**PROJECT NAME:** Beachfront RV Park Improvements / Port of Brookings-Harbor  
**PROJECT #:** 19005

**Addendum No. 2 for Beachfront RV Park Improvements**

The original Drawings and Specifications dated August 2021, are hereby modified and supplemented by this Addendum No. 2 dated September 23, 2021.

Figure 2 - Trench in ROW, Under Structure or Pavement, Etc.

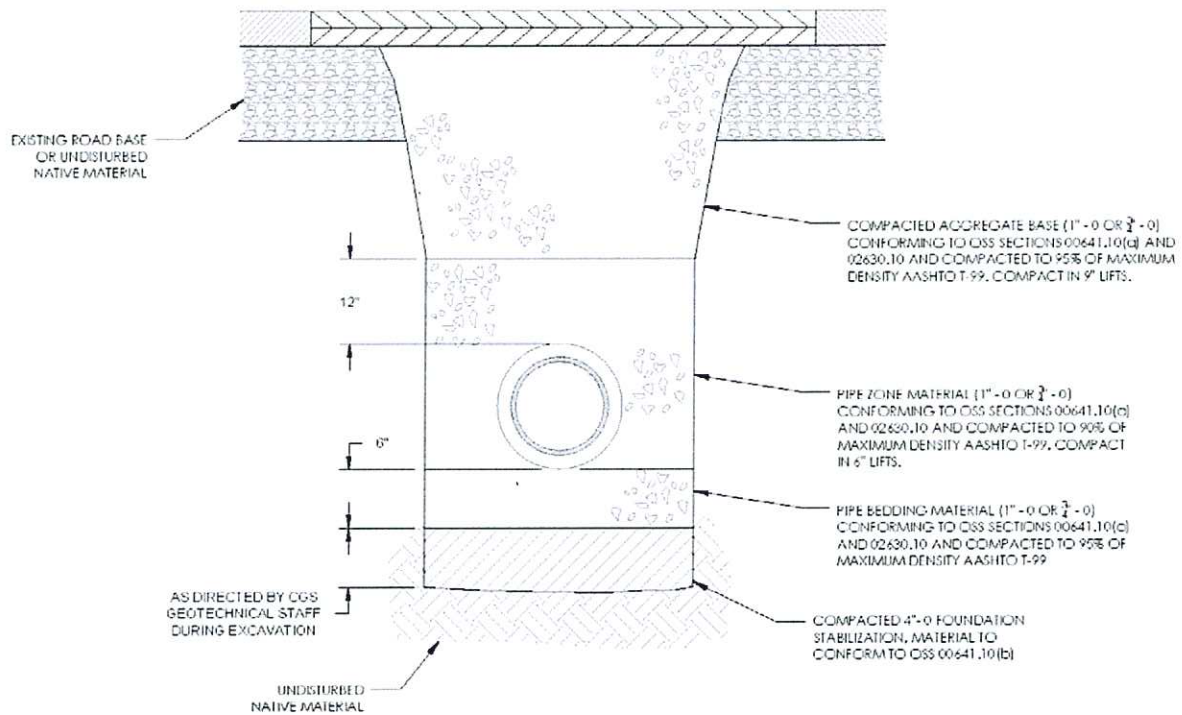
- Can native soils be used to backfill utility trenches?  
Answer: No, see Utility Trench Details attached.
- On sites 33 thru 38, can native soils be used up to 6" from finish grade?  
Answer: No, use gravel paving base coarse aggregate - 1-1/2" minus.

**CLARIFICATION:** Utility Trench Details attached.
